MONARCH RANCH AT MANOR PRELIMINARY PLAT

MONARCH RANCH AT MANOR
GREGG LANE & FM 973
OVERALL PRELIMINARY PLAT
MANOR, TEXAS 78653

Permit Number 2022-P-1439-PP
Job Address: Monarch Ranch Preliminary Plat, Manor, TX. 78653

Re: Monarch Ranch Preliminary Plan – 2022-P-1439-PP

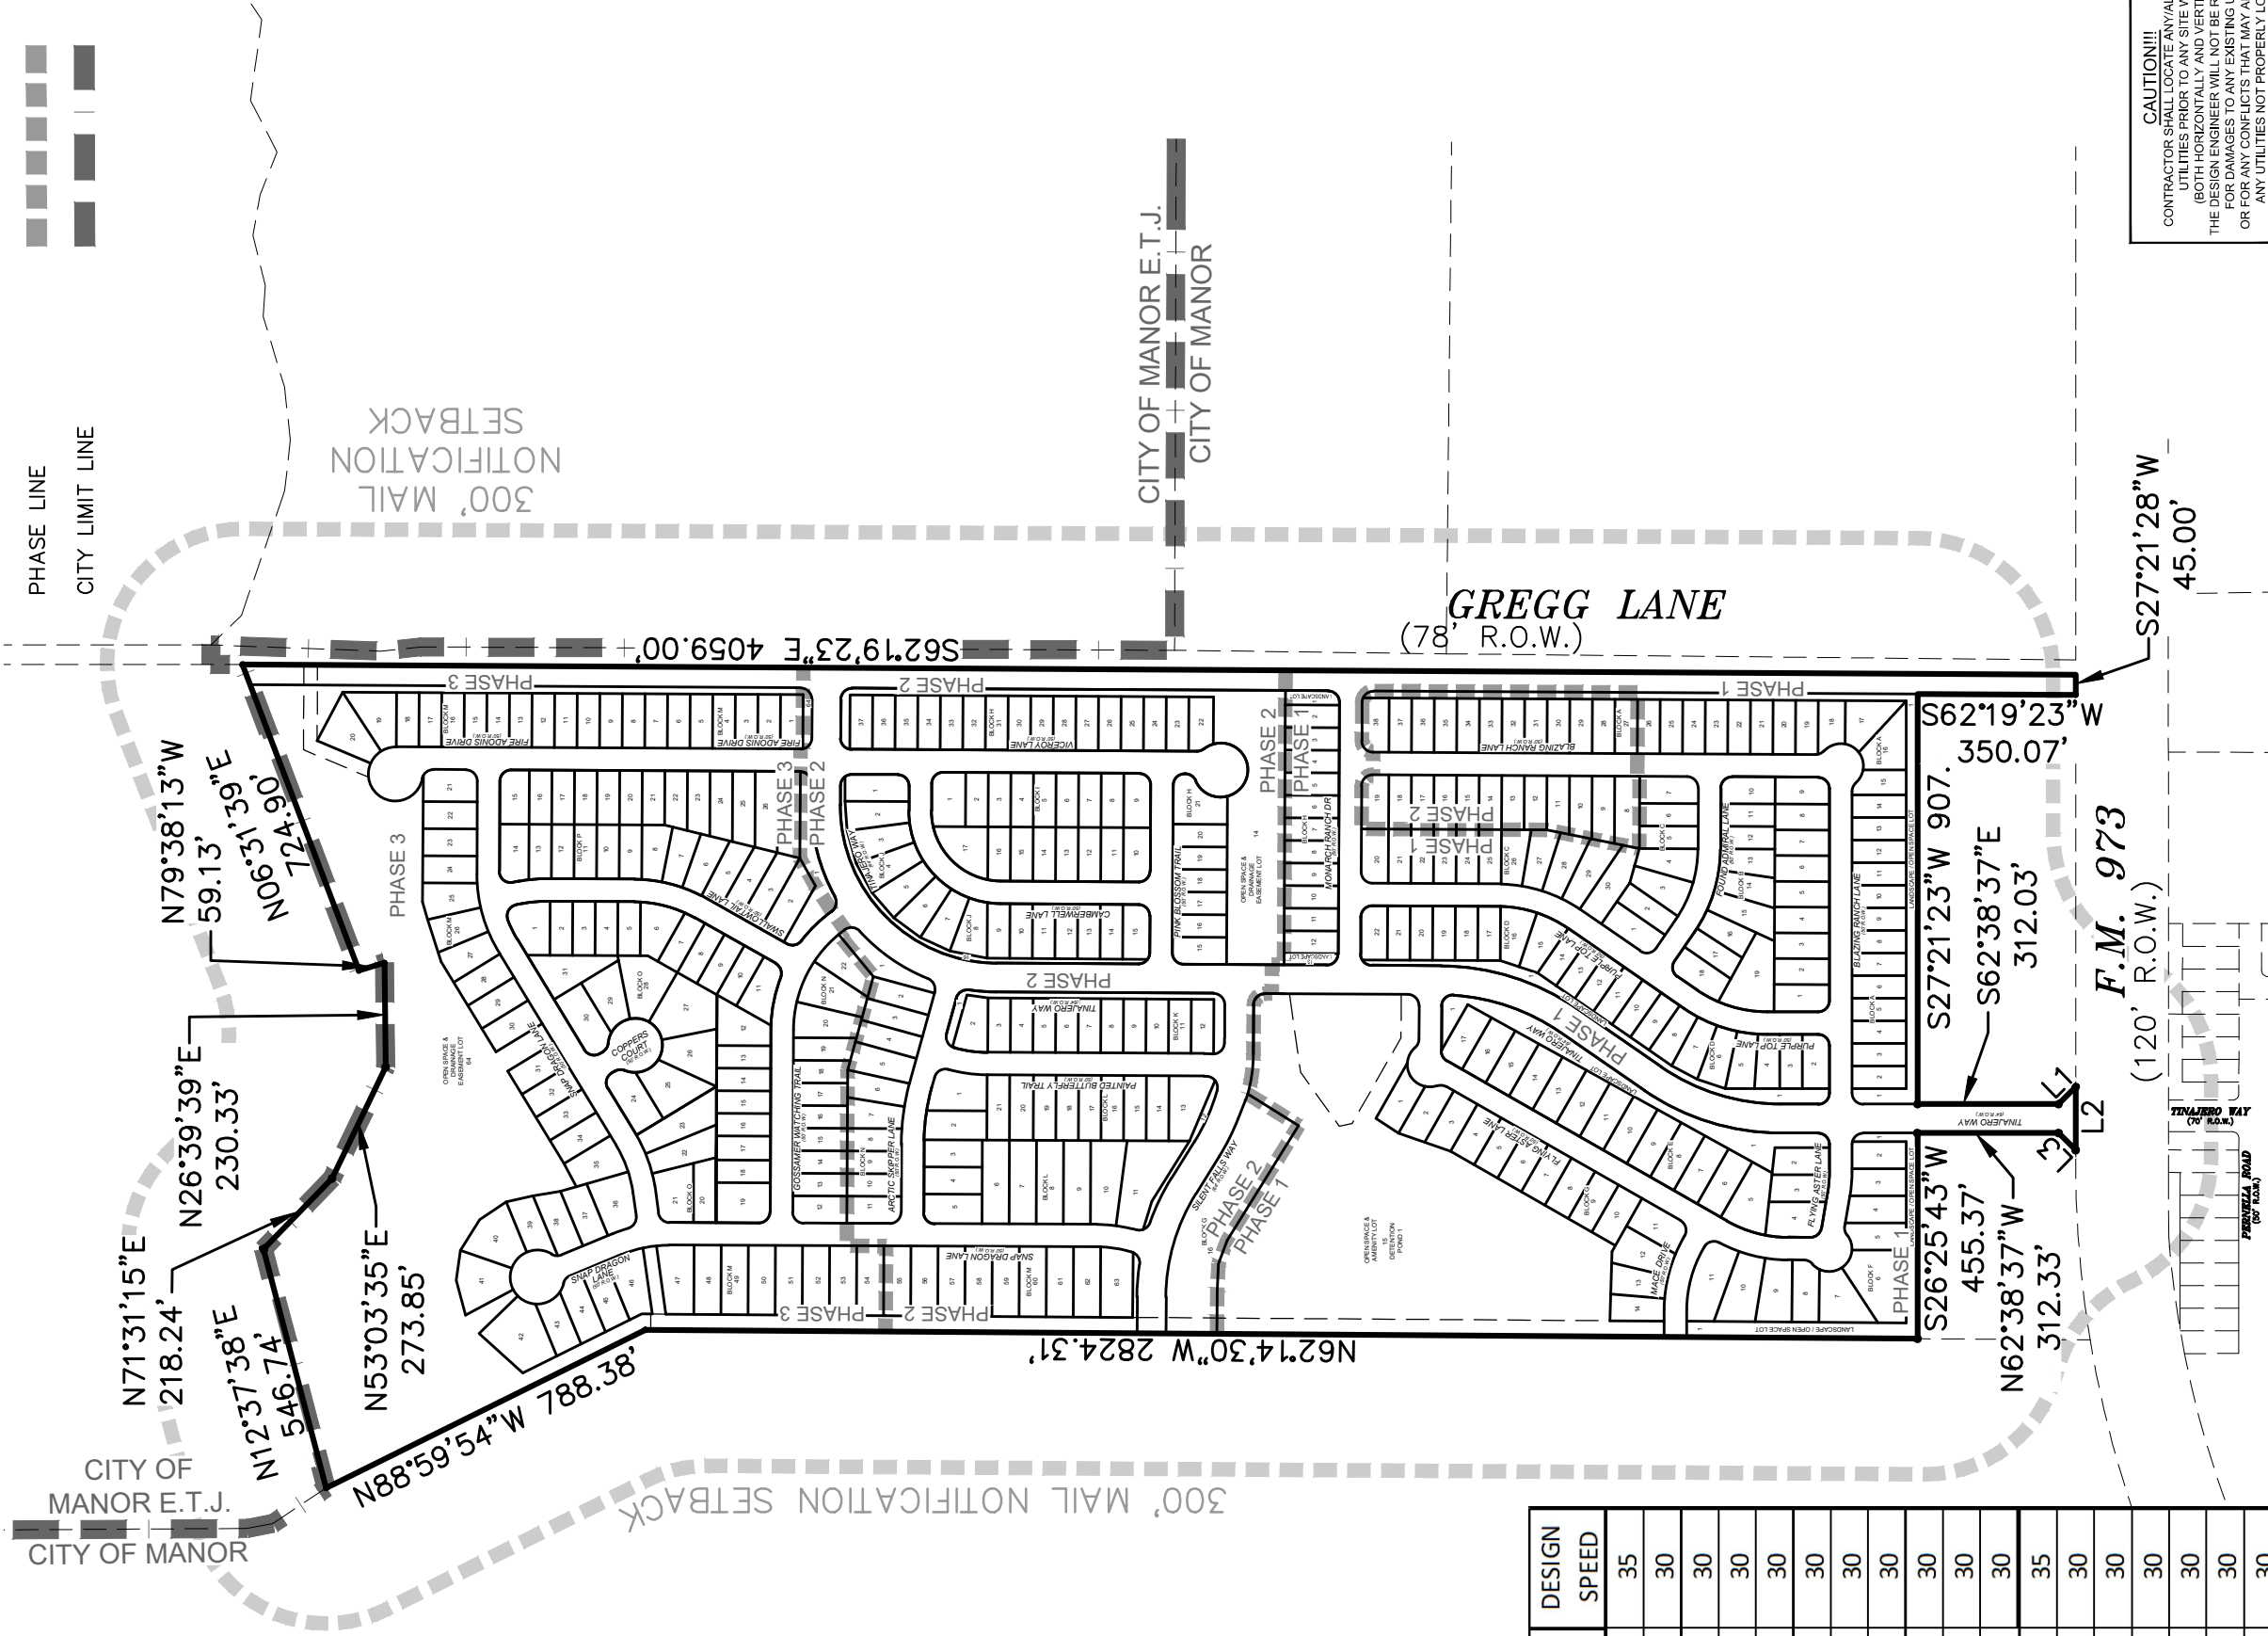
4. Update the City of Manor Acknowledgement, the current city Major is Dr. Christopher Harvey, Julie Leonard is the Chairperson, and Rebecca Guerrero is the Clerk of Travis County.

7. Provide R.O.W. width for F.M. 973 and Gregg Lane. The city of Manor is transitioning away from variable width R.O.W.

CITY ACKNOWLEDGEMENT HAS BEEN UPDATED AS REQUESTED. PLEASE SEE THE REVISED PRELIMINARY PLAN.

DIMENSIONS HAVE BEEN ADDED TO THE PRELIMINARY PLAN TO SHOW THE DISTANCE BETWEEN THE EDGE OF OUR PROPERTY AND THOSE ACROSS GREGG LANE AND FM 973. THESE DIMENSIONS DO NOT HAVE A UNIFORM DISTANCE. PLEASE SEE THE REVISED PRELIMINARY PLAN.
